IN THE DRAWINGS

REMARKS

Drawings

FIG. 6

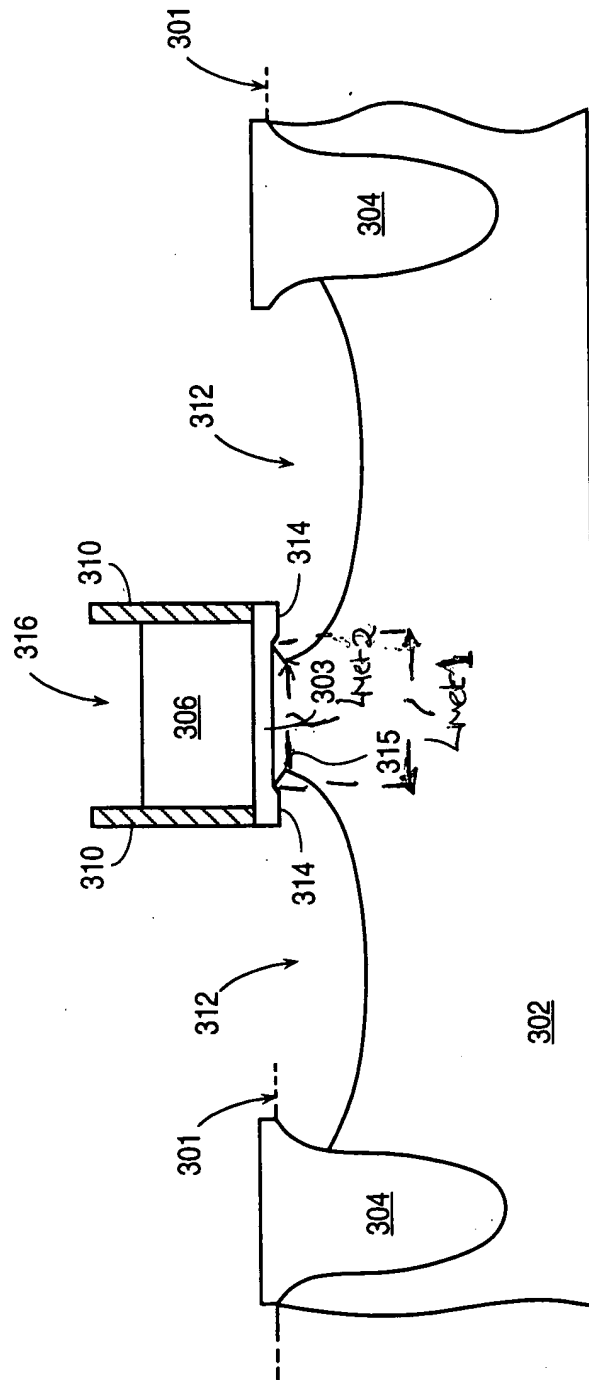
The drawings are objected to as failing to comply with 37 CFR 1.84(p)(5) because they include the following reference character(s) not mentioned in the description: L_{met} . See page 9, lines 10-17.

Applicants respectfully submit that the Examiner inadvertently made such a statement. Instead of stating that drawings do not include the reference character L_{met} mentioned in the description on page 6, lines 10-17.

Applicants submit herewith marked-up copies of drawings with a proposed correction in red, together with replacement drawings, for Figures 2 and 6 to comply with 37 CFR 1.84(p)(5). The amendments to the drawings have been made to include the reference character L_{met} mentioned in the specification in the paragraph on page 6 starting with words "The n-type region 206..." in description of Figure 2, and in the paragraph on page 16 starting with words "Yet another advantage of the lateral recess..." in description of Figure 6.

More specifically, Applicants here have amended drawings for Figures 2 and 6, to include L_{met1} , which denotes a larger physical or metallurgical channel length of the channel region directly beneath the gate dielectric, and L_{met2} , which denotes a smaller physical or metallurgical channel length of the channel region deeper into the substrate between the inflection points, as described in the specification in the above mentioned paragraphs on pages 9 and 16 with respect to Figures 2 and 6 respectively.
